DORAUJATH SUBDIVISION

APPLICATION NUMBER 12 DATE September 2, 2004

REQUEST Subdivision

DORAUJATH SUBDIVISION

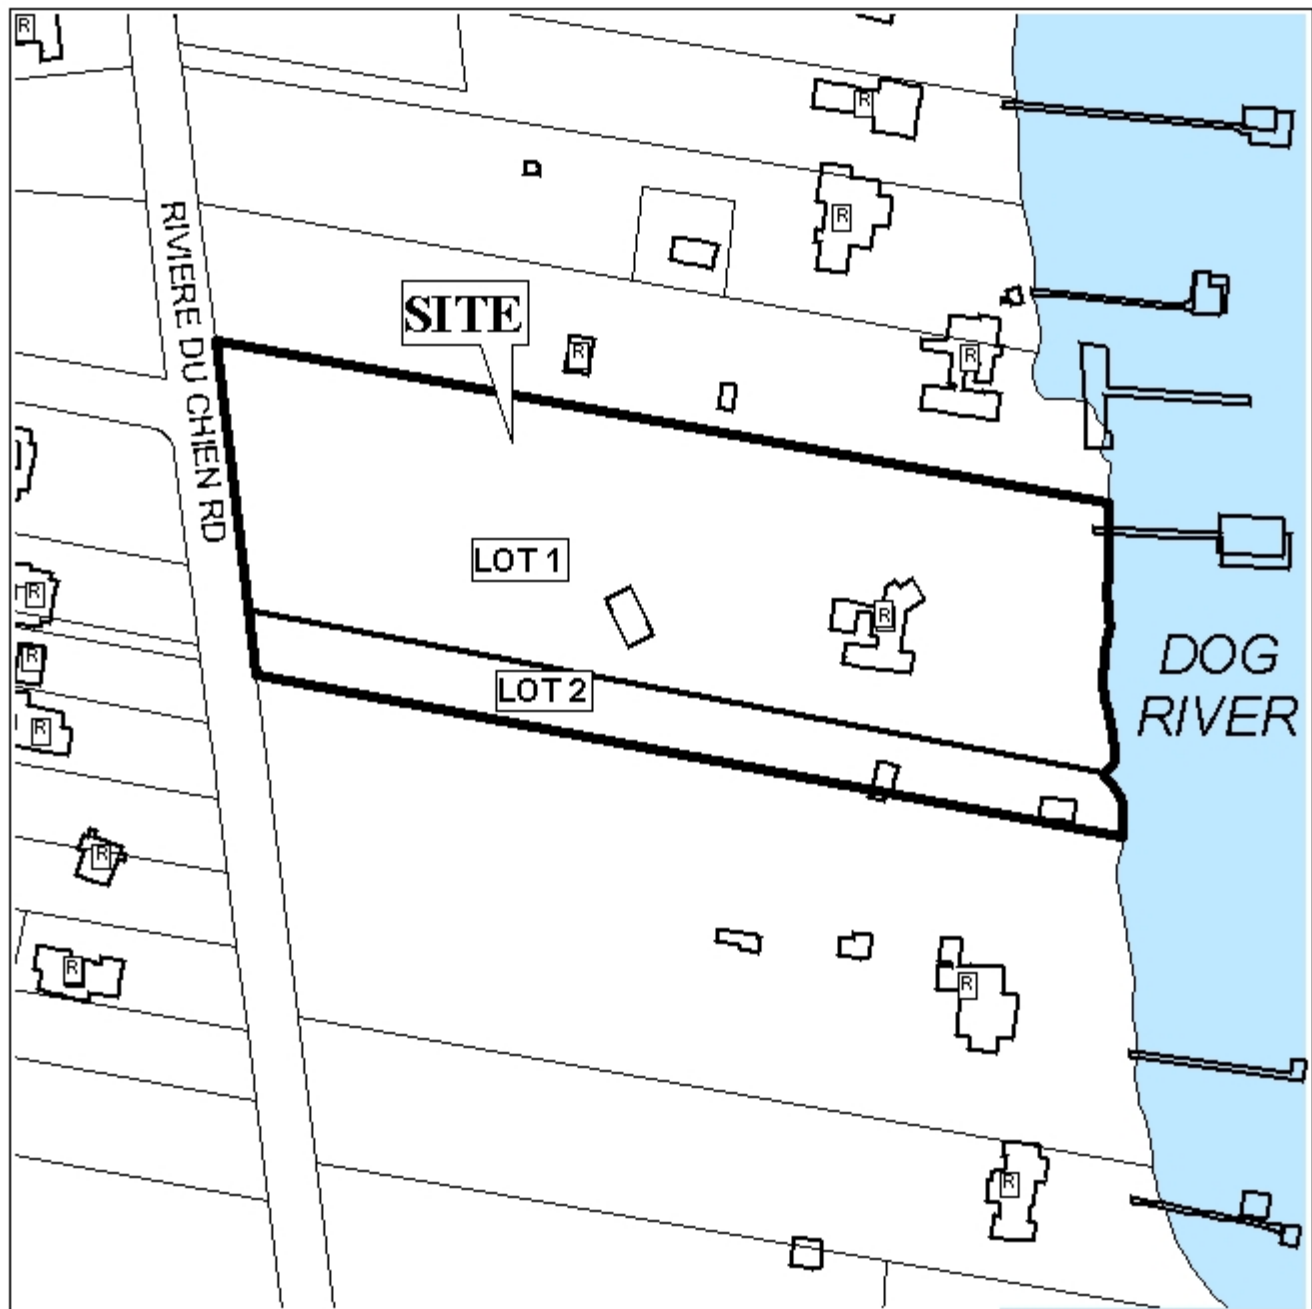
Lot 2 exceeds the maximum width to depth ratio as recommended by the Subdivision Regulations; therefore, a waiver of Section V.D.3., would be required. Narrow, deep lots are typical along waterways; thus a waiver of V.D.3. could be considered appropriate.

The 25-foot minimum building setback lines are not shown but would be required on the final plat.

Accessory structures are located on Lot 2 without a primary structure. Therefore, the accessory structures should be removed prior to the recording of the final plat so as not to create a violation of the Zoning Ordinance.

With modifications and a waiver of Section V.D.3., the plat will meet the minimum requirements of the Subdivision Regulations and is recommended for Tentative Approval subject to the following conditions: 1) the approval of all applicable federal, state and local agencies prior to the issuance of any permits; 2) the placement of the 25-foot minimum setback lines on the final plat; and 3) that the accessory structures on Lot 2 be removed prior to the recording of the final plat.
